STATE OF MAINE  
DEPARTMENT OF TRANSPORTATION  
16 STATE HOUSE STATION  
AUGUSTA, MAINE 04333-0016

October 12, 2021  
Subject: Station 46 Bridge Replacement &  
Pleasant Cove Bridge Replacement  
State WINs: 023929.00 & 023929.01  
Location: **Woolwich**  
**Amendment No. 4**

| STATION 46 & PLEASANT COVE BRIDGES<br>KENNEBEC RIVER ESTUARY<br>WOOLWICH SAGadahoc COUNTY |                                      | CONCEPTUAL TEMPORARY<br>ALIGNMENT 1    |             |

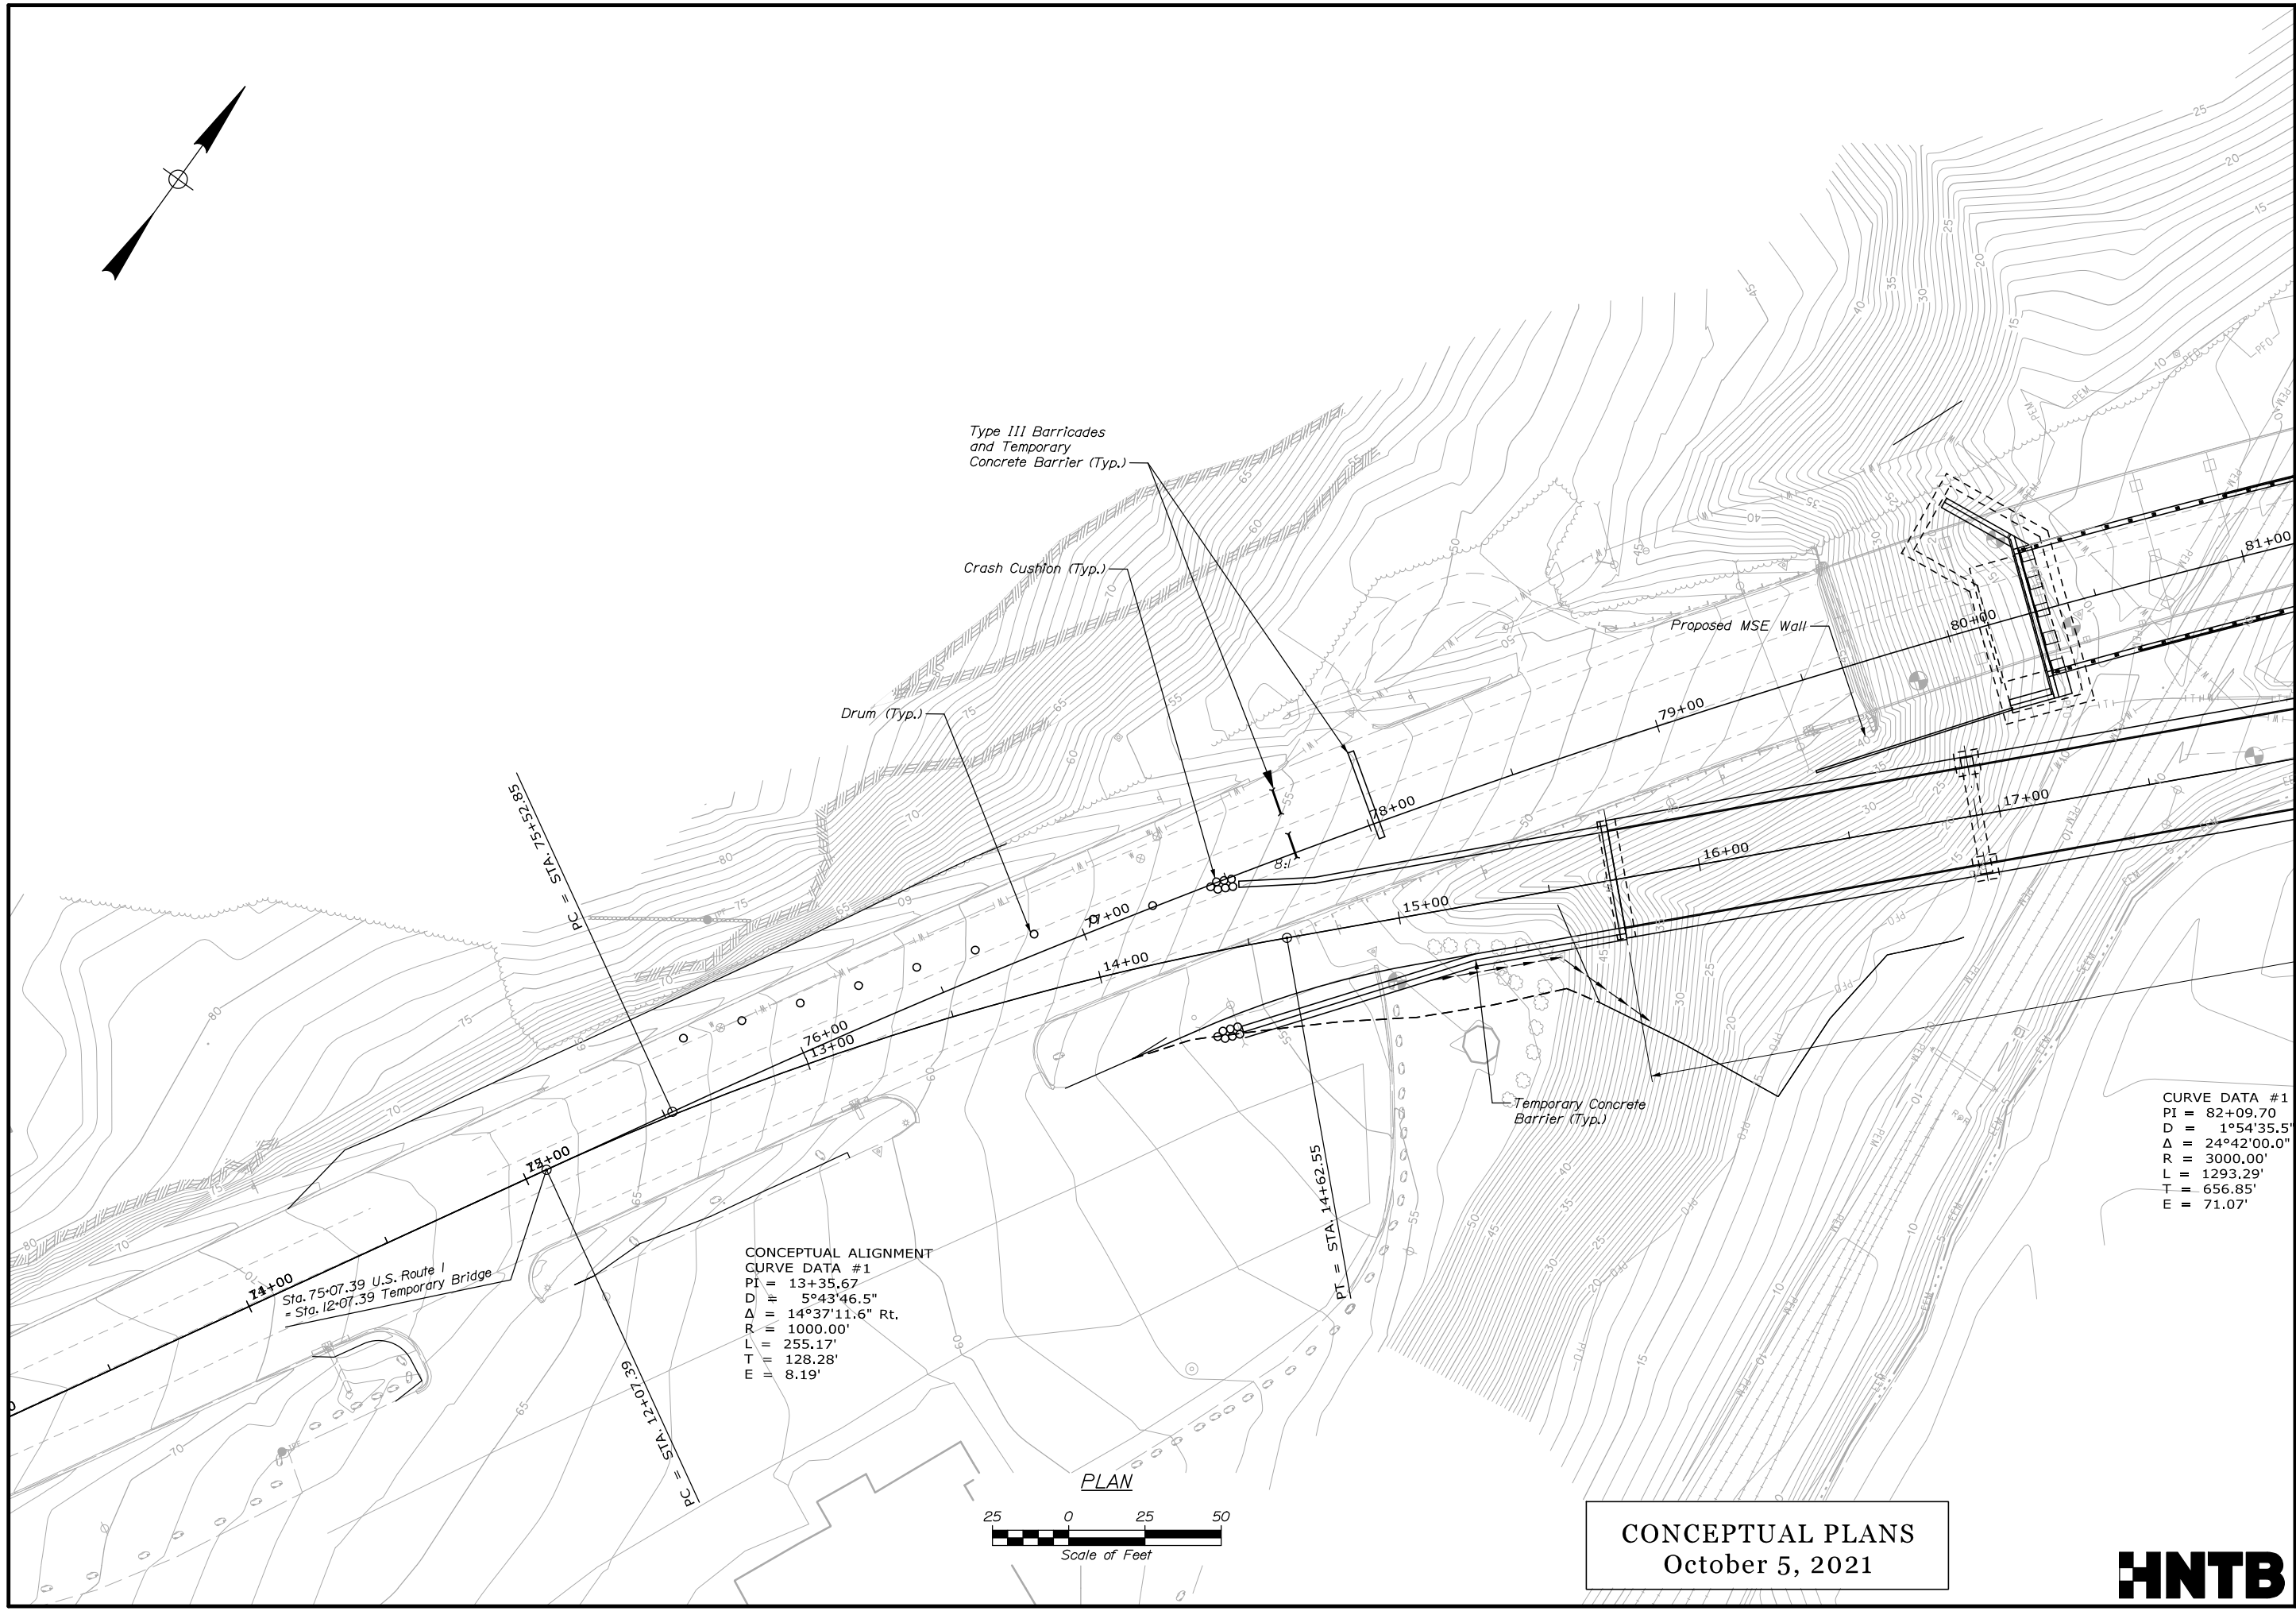
**Question:** Could you provide the conceptual horizontal alignment for the temporary detours as described in SP 510?

**Response:** Please see the attached file name "Conceptual Special Detour horizontal alignment" for the Departments conceptual special detour layout. Please note that this layout is conceptual, and the Contractor shall perform their own independent design or check of the alignment.
